GULF STATES UTILITIES COMPANY

April 10, 1984
RBG-17,552
File No. G9.5,
G9.8.6.2

River Bend Station - Unit 1
Docket No. 50-458

Enclosed are the results of Gulf States Utilities Company (GSU) studies regarding the effect on plant structures and slopes of ponding in the Unit 2 excavation. These studies respond to open items identified in the Draft Safety Evaluation Report (DSER) by the Environmental and Hydrological Engineering Branch (EHEB) and the Structural and Geotechnical Engineering Branch (SGEB). The analyses indicate, as described in the revised Final Safety Analysis Report (FSAR) text, ponding in the excavation area will not affect the structural integrity of adjacent plant structures nor will maximum ground water levels affect any other River Bend Station (RBS) structures if a berm is constructed around the excavation area. Hence, GSU will place a berm around the Unit 2 excavation to prevent runoff flow into the area and maintain plant structural integrity. Enclosure 1 addresses the methodology, analysis, and results of the ponding study, including the addition of a berm. Enclosure 2 addresses the stability of plant slopes. The revisions indicated in this transmittal will

FIGURE 2.5-72b

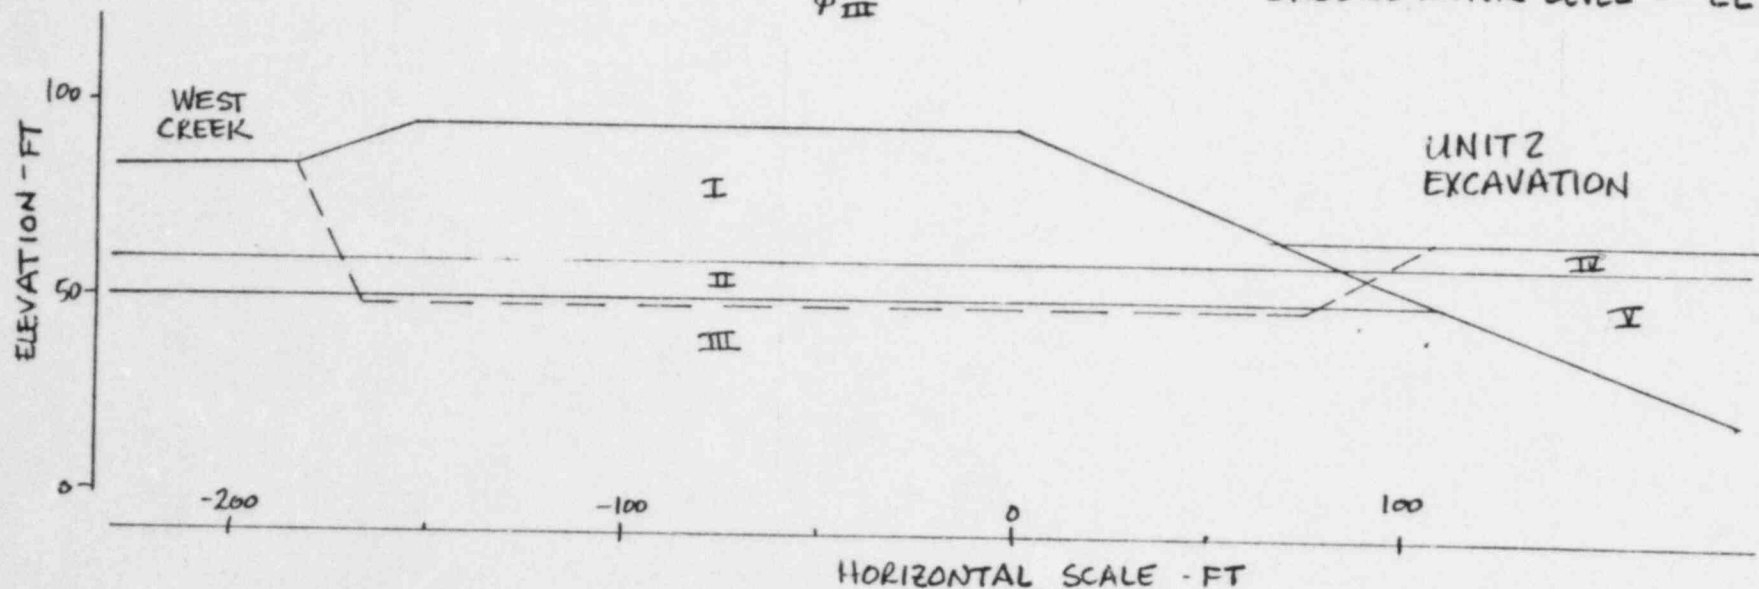
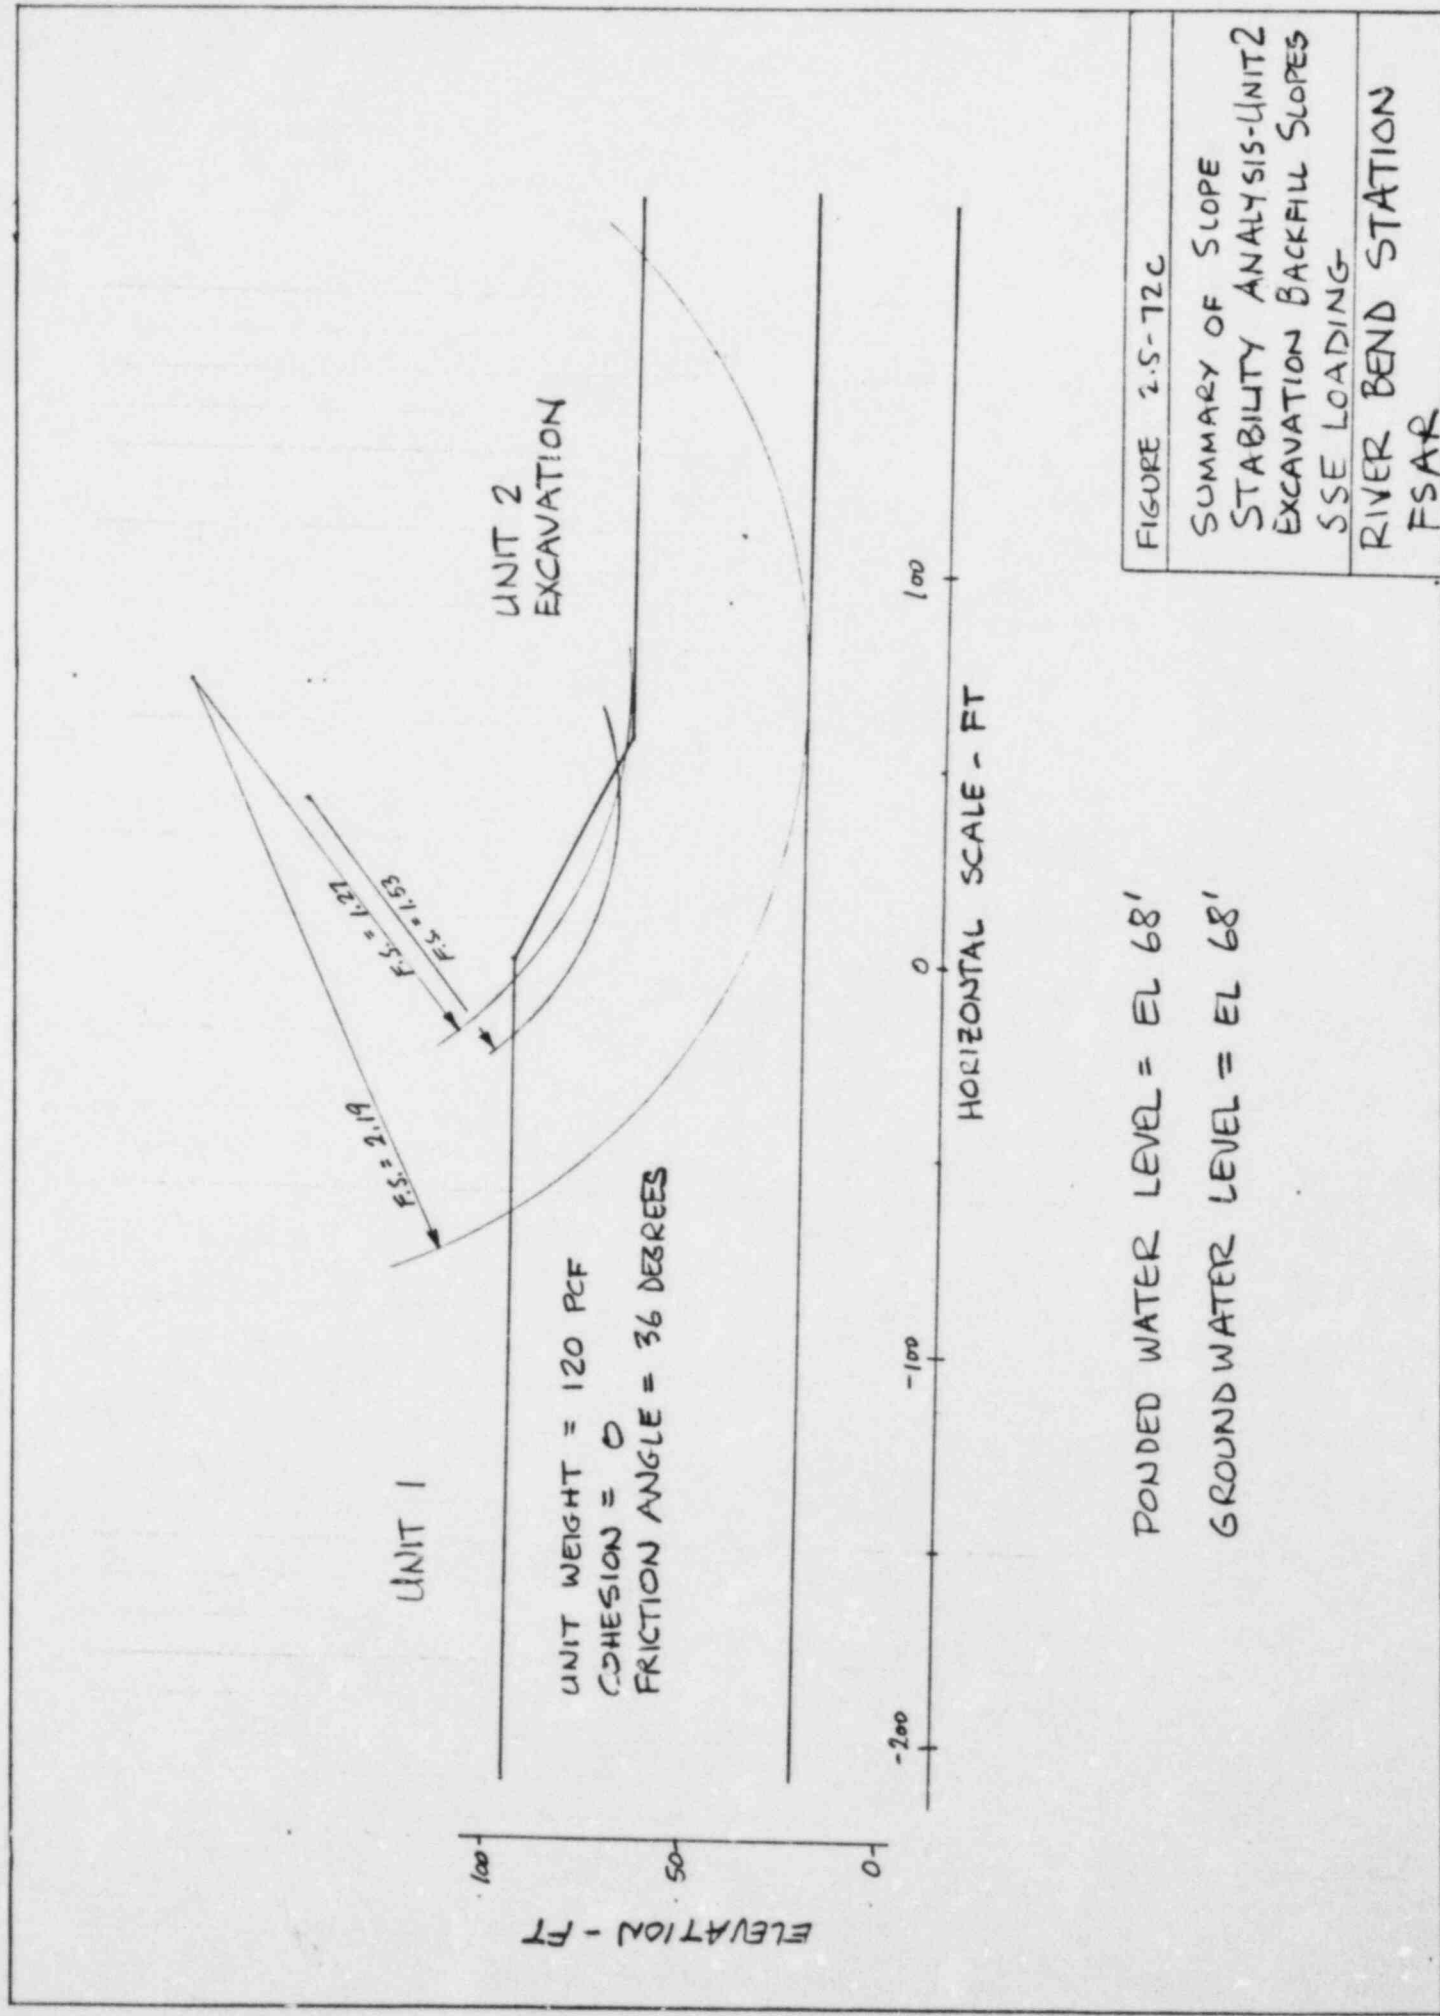
The impact of liquefaction of localized inclusions of loose sand was evaluated in the stability calculations by varying the strength parameters for soils below elevation 50 ft msl. Cut slopes were analyzed using angle of internal friction values of 10, 20, and 35 for soil below elevation 50 ft msl, which correspond to approximately 75%, 50% and 0% liquefaction, respectively. Figure 2.5-72b shows the geometry that was used to model the west slope.
